**Recall Campaign 11V-332: Replace Alternator Drive Belt Tensioner**

E70 (X5 xDrive35d) with M57Y engine

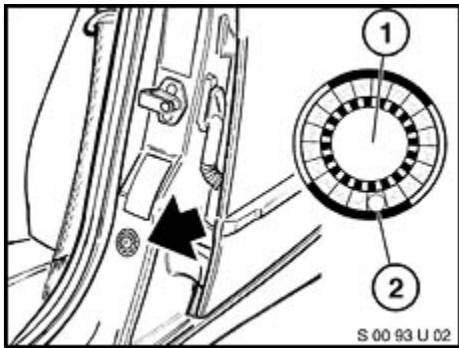
The power steering and alternator engine drive belt tensioner aluminum support may crack at the welded seams. If a failure should occur, the vehicle would exhibit a loss of power steering assist. It is still possible to steer the vehicle by applying greater force while turning.

Replace the power steering and alternator engine drive belt tensioner as per Repair Instruction REP 11 28 020. The power steering and alternator engine drive belt replacement is not needed.

The current level of ISTA/D does not provide a torque specification for the torx M6 x 20 fasteners. Both torx M6 x 20 fasteners are to be reused and tightened to 8 Nm of torque.
